Rebuttal Biodiversity Evidence of Oliver Ramm, RammSanderson Ecology Ltd.

Land off Leconfield Road, Nanpantan, Loughborough

Appeal against the refusal of Outline Planning Permission for a residential development with associated infrastructure for up to 30no. dwellings, including detail of associated point of access. All other matters (landscaping, scale, layout and appearance) reserved.

PINS ref: APP/X2410/W/22/3304644 LPA ref: P/20/2199/2

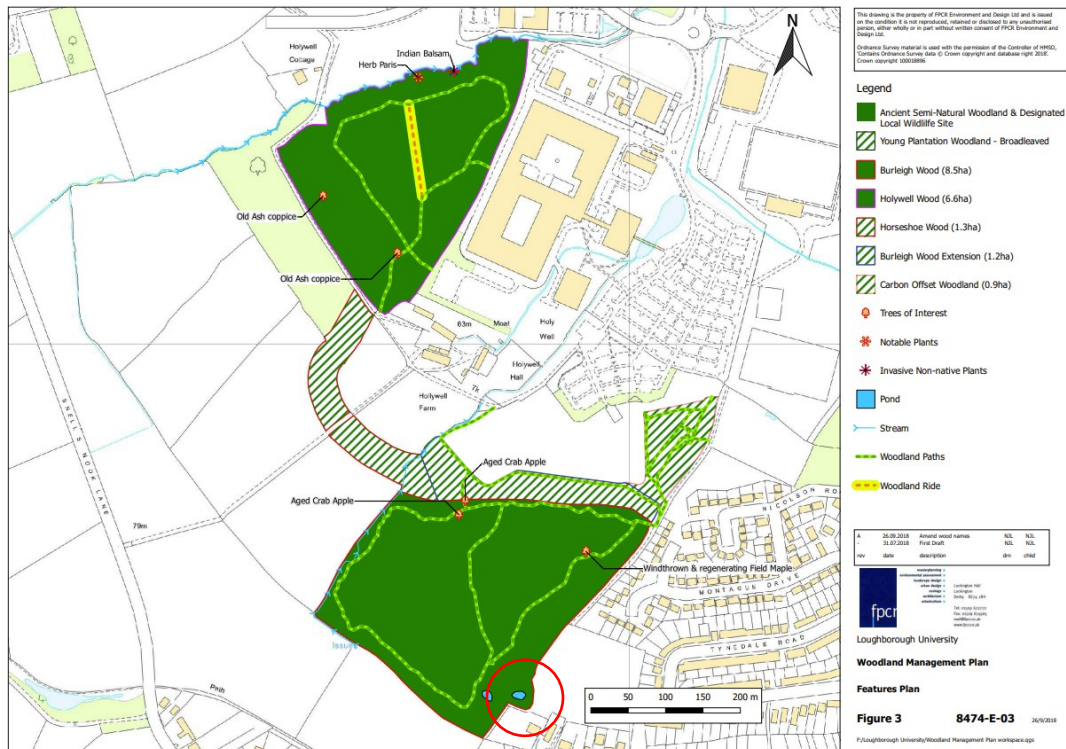
3.1 To demonstrate the differences between Ms Walsh’s Drawings, and the actual situation, it is necessary to have regard to the Natural England Inventory of Ancient Woodlands, a GIS dataset held on the publicly available www.magic.defra.gov.uk website. An extract is provided below, with the layer showing the Ancient Woodland inventory (vertical green line hatching). A full page extract is also included at Appendix 1 of this document.

3.2 This clearly shows that the extent of Burleigh Wood Ancient Woodland follows the line of the Appeal site boundary and does not extend into the site.

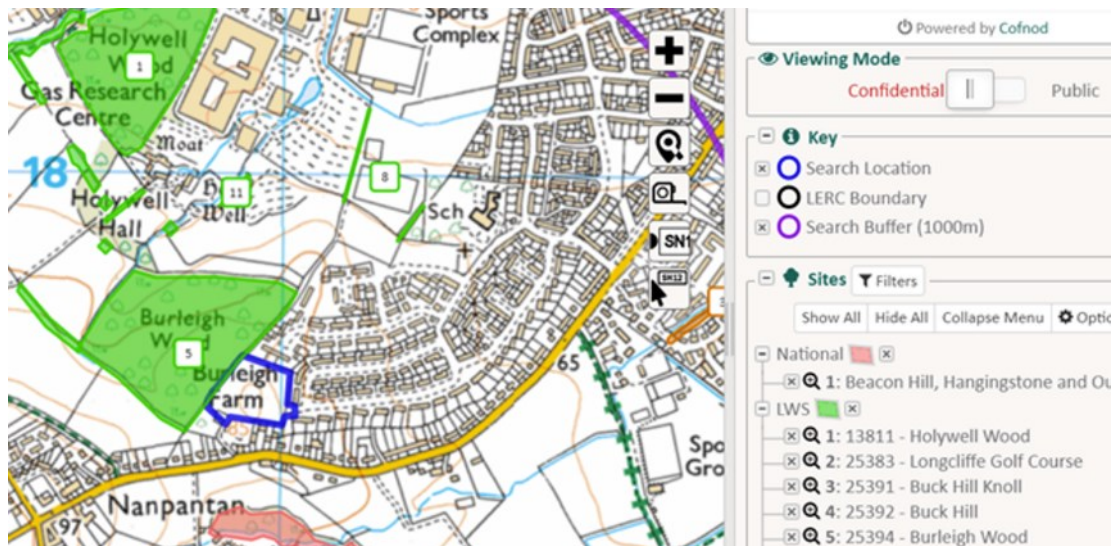
3.3 Whilst the Loughborough University Management Plan for Burleigh and Holywell Woods includes plans that show an area within the Appeal site that extends Burleigh Wood slightly into the site, this is not to be confused with the extents of ancient woodland, as per the Natural England database extent shown above. An extract from the management plan is given below (Figure 3 of CD.5.2.14) showing the extents of the woodland. It is considered a mapping error within the management plan, to show the extent of ancient woodland (in the key) as the same as the extent of Burleigh Wood, and the LWS citation. This also shows a pond on the site boundary which is not present.

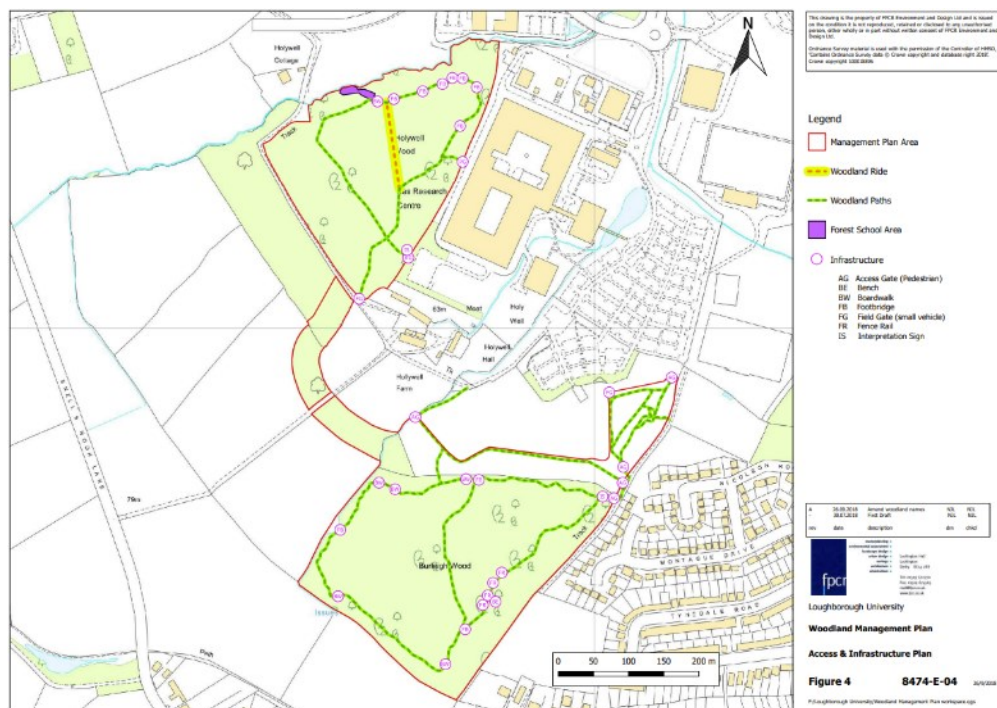
3.4 It is further noted that the extents of the Local Wildlife Site citation, as shown in the extract from the Leicestershire Environmental Records Centre database below, also follows the appeal site boundary, rather than the boundary given in the woodland management plan.

Figure 4: Existing flow paths onsite.

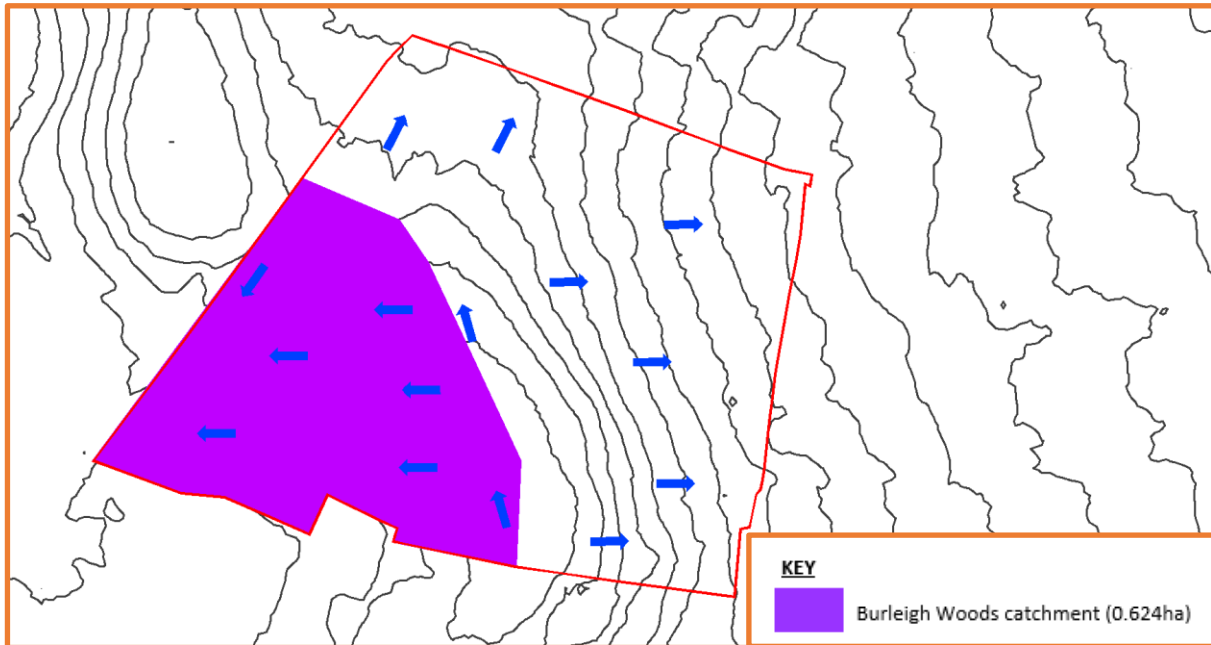
- 3.11 The existing flow paths onsite are shown to follow the natural topography of the site; which declines in all directions from the site's peak which extends from a central region within the site to the site's southern boundary. In the west of the site the flows are predicted to route in a south-westerly direction and discharge into the woodland. Ground level levels begin to incline again once within the woodland, so any surface water flows from the site will not impact the majority of the woodland.

- 3.12 Figure 4 also demonstrates an outline estimate of the existing catchment onsite draining to Burleigh Woods in the west; this has been based upon the existing site topography. The existing catchment area draining from the site to Burleigh Woods is approximately 0.624ha.

Figure 5: Burleigh Woods catchment alongside sewer network catchment

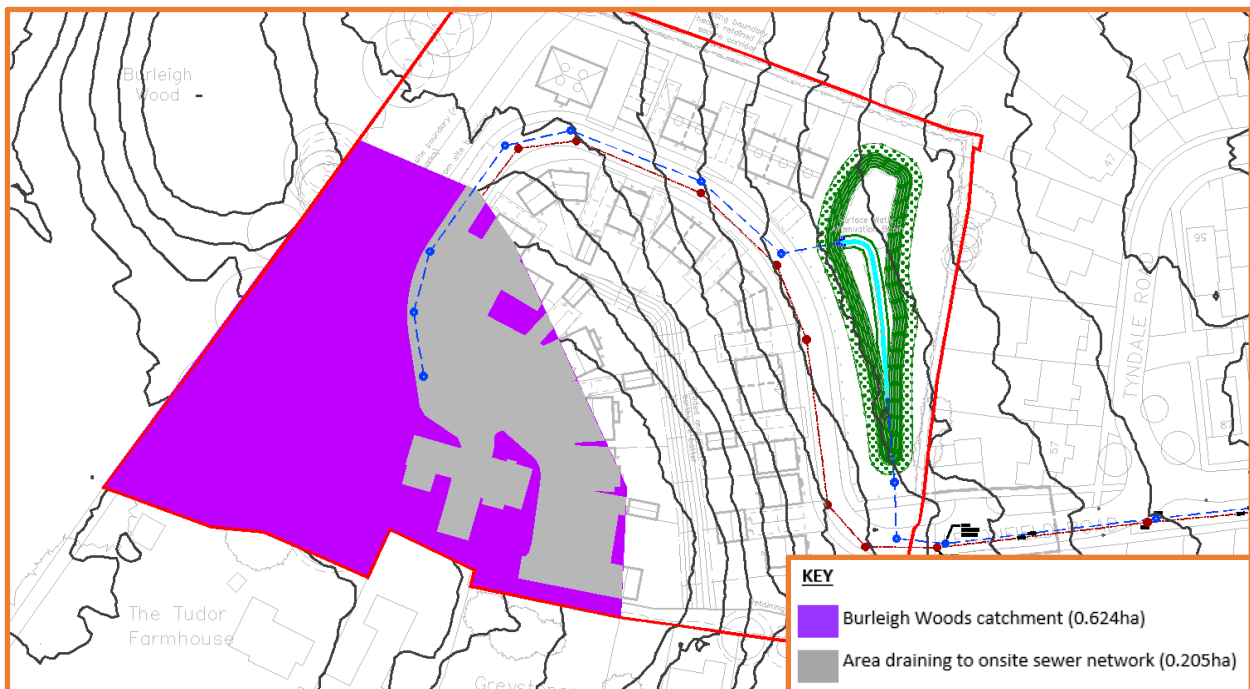
- 4.5 The purple shaded area in the west of the site without any grey shading demonstrates the wide margin of open space that will be retained as grassland. This open space area will retain the same drainage characteristics as existing, and as such any rainfall on this area will either infiltrate into the underlying ground or drain via overland flow to the south-west. The maintenance of the potential for infiltration into the sites subsoil along the western boundary, as per existing pre-development conditions, will ensure that groundwater conditions along the boundary of the site and hence adjacent woodland area will remain the same.
- 4.6 The proposed impermeable surfaced areas (e.g. roofs, driveways and roads) will drain to a positive drainage network which discharges to the SuDS basin in the north-east.

- 4.7 Figure 5 above demonstrates that the area to be diverted to the onsite sewer network is approximately 0.205ha. A greenfield runoff calculation has been conducted within Microdrainage based upon this area, see **Appendix B**. The outputs demonstrate that the QBAR rate for the diverted catchment area is 0.9l/s, this is equivalent to 0.0009m³/s. The flow rate of 0.9l/s is considered a very low flow rate and would be the amount of water effectively diverted away from the woodland area as a result of the proposals, rather than draining to the woodland.

Figure 6: Exceedance plan alongside indicative swale drainage route.

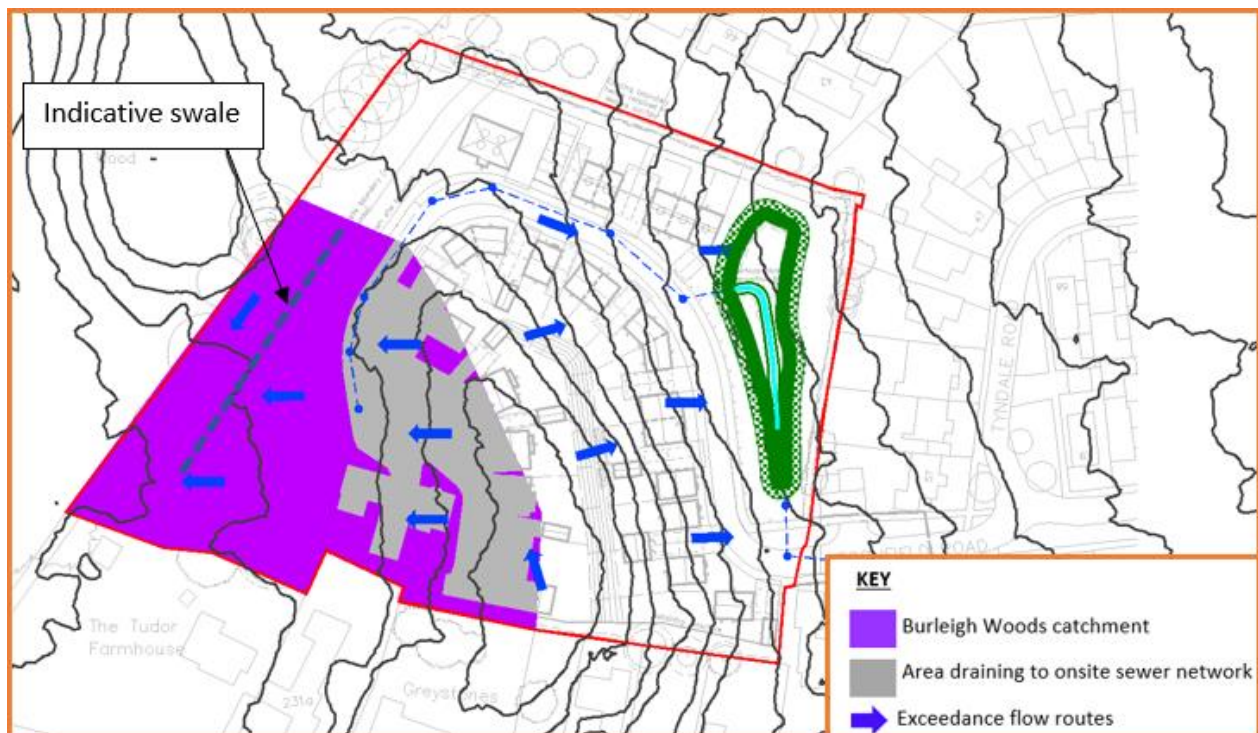
- 4.8 Figure 6 below shows the predicted route for overland surface water flows for the post development scenario. The development proposals comprise a wide-open space area in the west of the site which will be grassland, this mimics existing conditions. Therefore, the route and direction of any overland surface water flows within these extents will be the same as existing. Subsequently the location at which any overland flows might discharge to the woodland area will also reflect existing conditions.

- 4.9 Furthermore, the proposed onsite earthworks are to retain existing topographical patterns where practical, therefore in extreme storm events exceedance flows from the proposed areas of hardstanding within the site's south-western extents, beyond the capacity of the proposed onsite sewer network, will continue to flow towards the woodland. The creation of impermeable areas will tend to increase the likelihood of overland flow being generated during extreme storm events, therefore overland flow to the woodland area may be increased during these instances of heavy rainfall events.
- 4.10 To further enhance the connectivity of the adjacent woodland with exceedance flows from the south-western extents of the site it is proposed that a swale is to be located through the open space area parallel to the site's western boundary, an indicative route is demonstrated within Figure 6 above.
